A Performance Assessment Methodology for Low-Level Radioactive Waste Disposal Facilities

Recommendations of NRC's Performance
Assessment Working Group

U.S. Nuclear Regulatory Commission
Office of Nuclear Material Safety and Safeguards
Washington, DC 20555-0001

A Performance Assessment Methodology for Low-Level Radioactive Waste Disposal Facilities

Figure 3. Section 3.1: Detail to the "Example of an Acceptable Process for Demonstrating Compliance with 10 CFR 61.41." The activities shown by the dotted lines depict the compliance review the NRC staff is expected to perform.

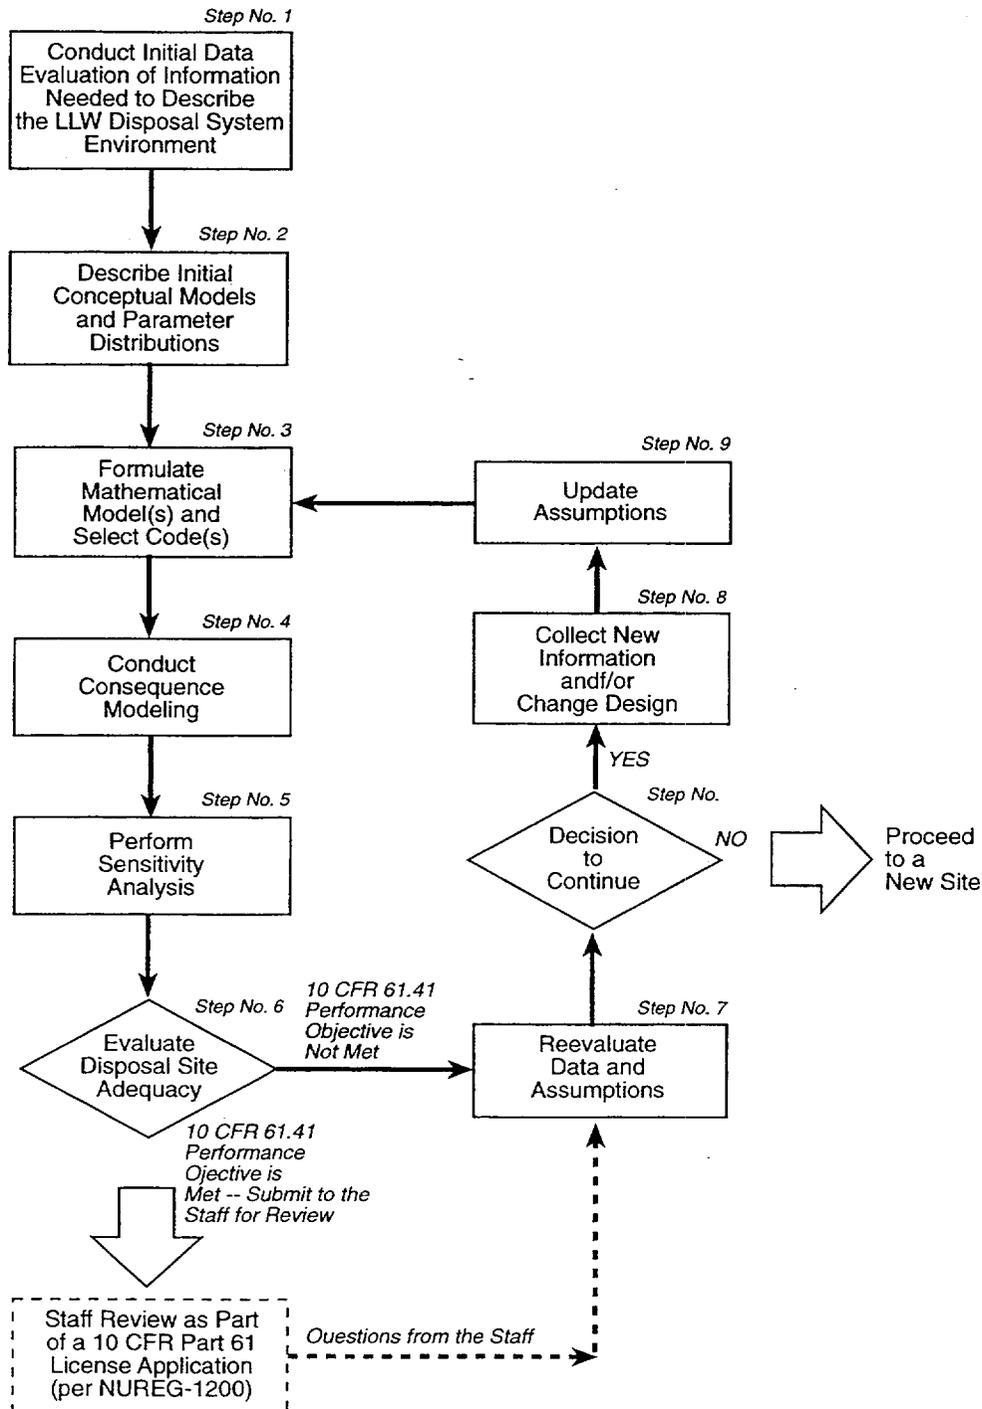
11. Page 3-2; "Branch Technical Positions (With Discussion)," Figure 3. Where does the option of limiting radionuclide inventory fit into this flow chart? Limits on radionuclide inventory may change a disposal site's rating from "inadequate" to "satisfactory."

7. Page 1-15, Paragraph 3. We strongly concur, and hope that the regulators are able to participate in such a process without compromising their objectivity. This might be indicated on Figure 3 [Technical Position 3.1: Detail to the "Example of an Acceptable process for Demonstrating Compliance with 10 CFR 61.41"], if appropriate.

In practice, the PAWG believes that the approach outlined in Section 3.1 of this technical report (and depicted in Figure 3) should result in a supportable demonstration of compliance with 10 CFR 61.41. *Step No. 6* of the process is the logical ending point for the required assessment; specifically, having

As noted in the response to *Golder Associates' General Comment No. 6*, the PAWG believes one of the tenants of good and effective regulation is to interact early and frequently with potential licensees. With this philosophy in mind, the NRC staff (or any other State regulatory authority) would, at the request of potential licensees, interact on any or all of the LLW performance assessment process steps described in Figure 3.

Figure 12. Conceptualization showing potential surface water contamination pathways. (All radionuclides distributed in the aquifer, in the vicinity of the surface-water body, are discharged into it.)

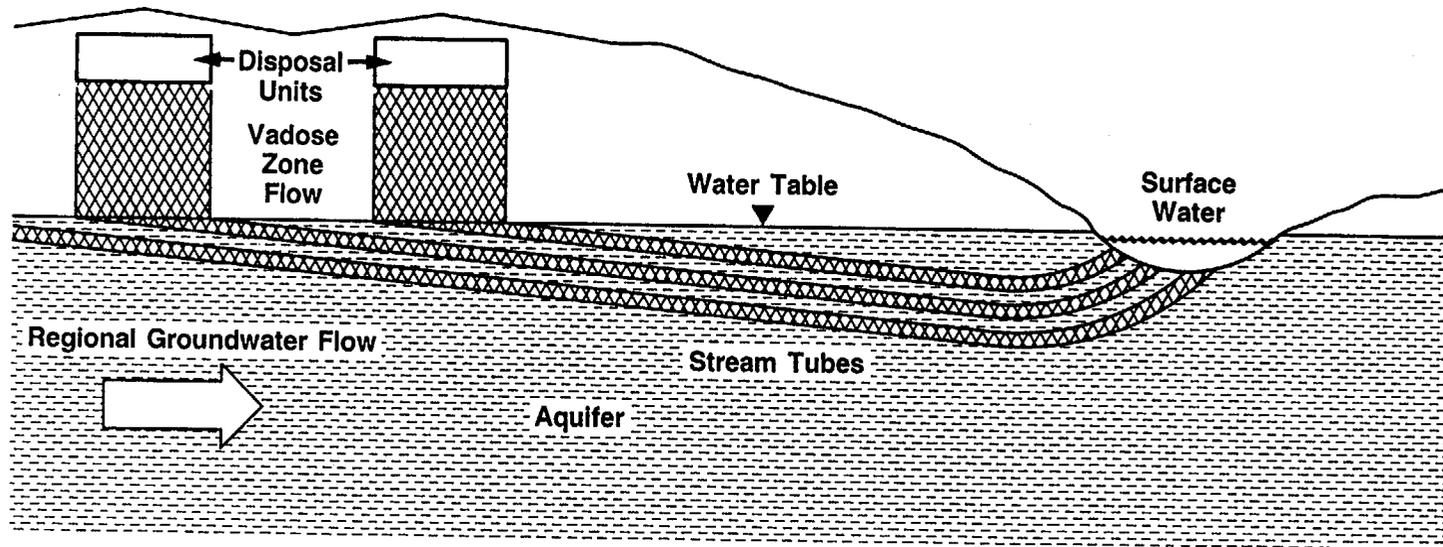
5. Section 3.3.6.2.1, "Surface Water. Considerations" (p. 3-61): The first sentence of this section references Figure 13. Figure 12 appears to be the more appropriate reference.

Figure 14. Example of potential dose pathways to be considered in an LLW performance assessment. [Determination of appropriate pathways depends on site-specific information (i.e., habits of the critical group). Adapted from EPA (1972).

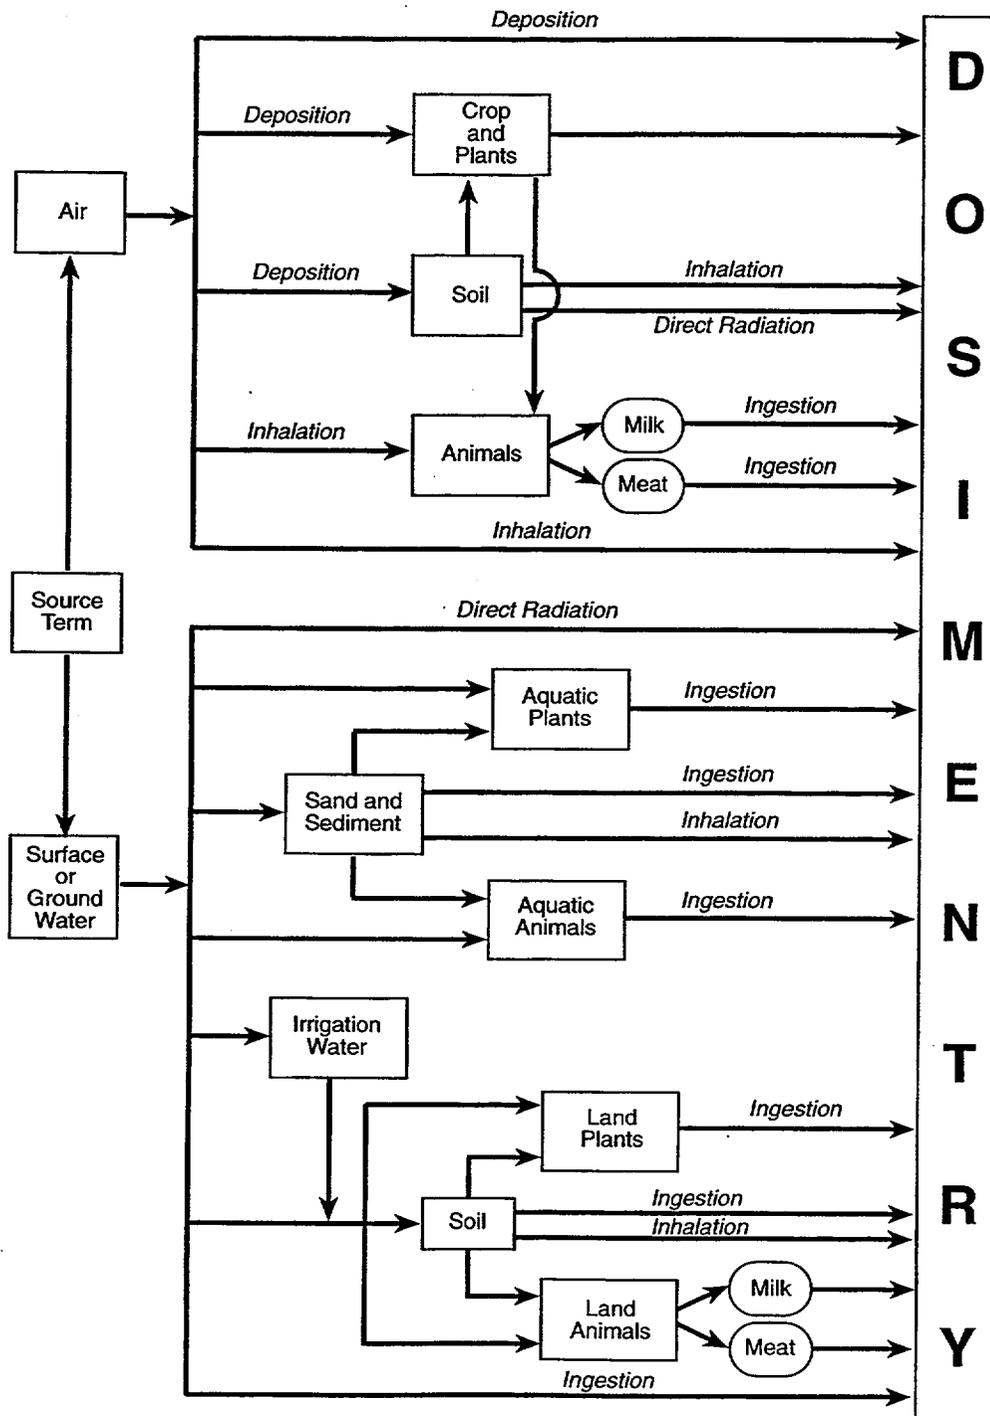
2. Page 3.75, Figure 14, this figure contains an unusual label [sic] "Fishing and Sports Gear." If this level of specificity was used uniformly throughout the diagram it may become too cluttered to be useful.

7. On Figure 14, the mechanism by which exposure is received by the individual (i.e., ingestion, inhalation, direct radiation) is identified in italics for some but not all of the pathways depicted. Specifically, the milk and meat pathways at the bottom of the figure should specify "ingestion," and the fishing and sports gear category and sand and sediments category should specify "direct radiation" if that is the intent.

The PAWG agrees with this comment. Figure 14 has been revised accordingly.

Figure 14 has been revised based on these comments.

Figure B-2. PAWG-recommended approach to calculating the peak of the mean dose.

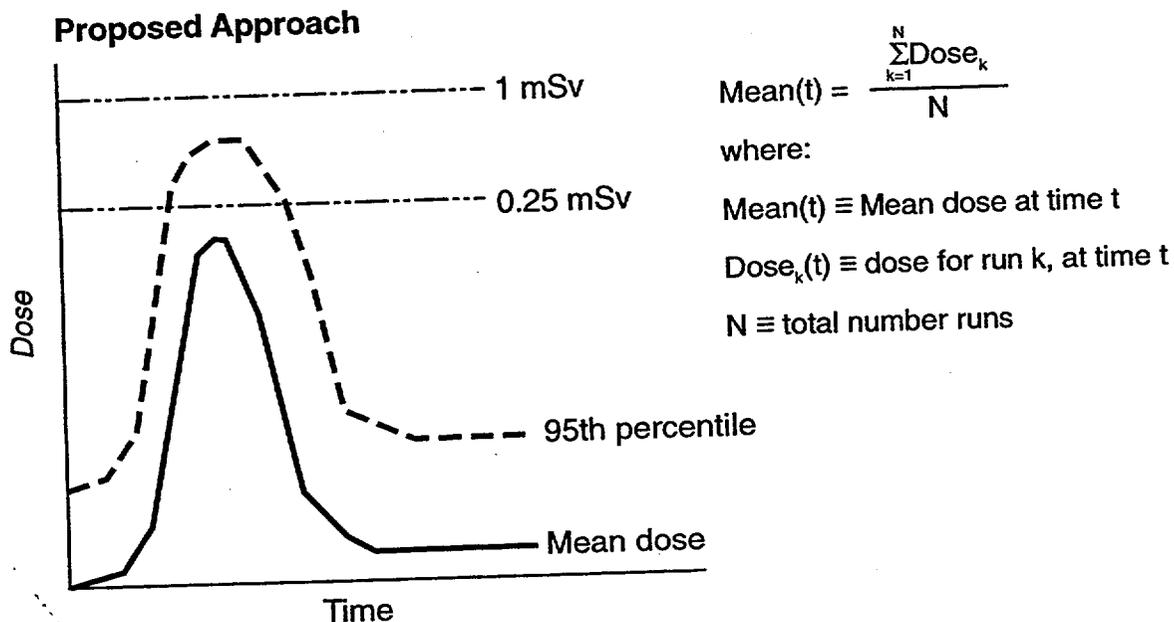
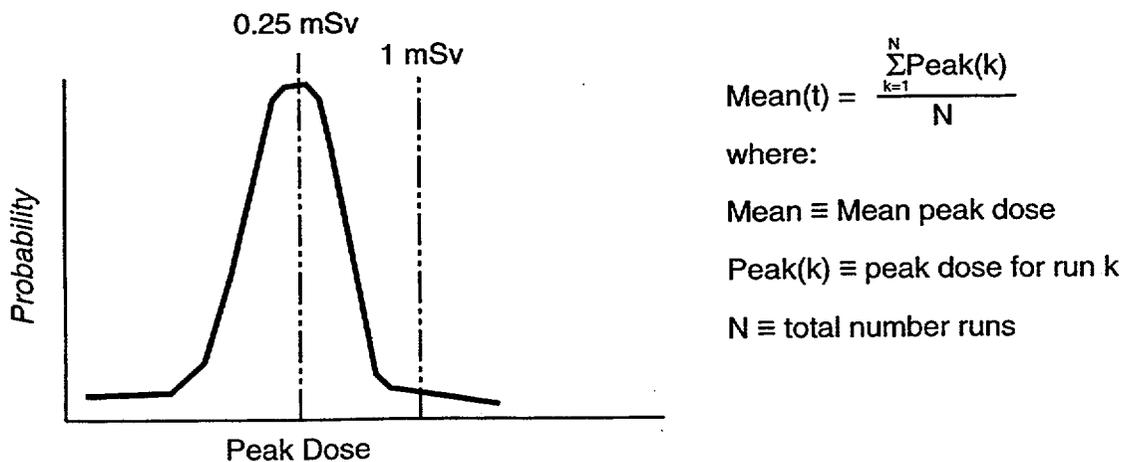
disposal system and is the most direct measure of risk. See Figure B-2. Further, placing a limit on the upper 95th percent confidence of the dose distribution provides additional assurance of the acceptable performance of the site – constraining the 95th percentile of the distribution to 1.0 milliSievert (mSv) [100 millirem (mrem)], as shown in Figure B-2. [In response to this and other comments, the PAWG staff have modified Paragraph No. 2 of Section 3.3.2.3.2 of this technical report (“Probabilistic Analysis”) to describe how the mean dose as a function of time can be derived mathematically, consistent with Item (a), shown in Figure B-2.]

Essentially, a mean dose is determined at each discrete time-step in the analysis. A plot is then made of these means versus time. The mean dose provides the "best estimate" of dose at each discrete time. The overall peak of these best estimates is then used to determine compliance with the regulation.
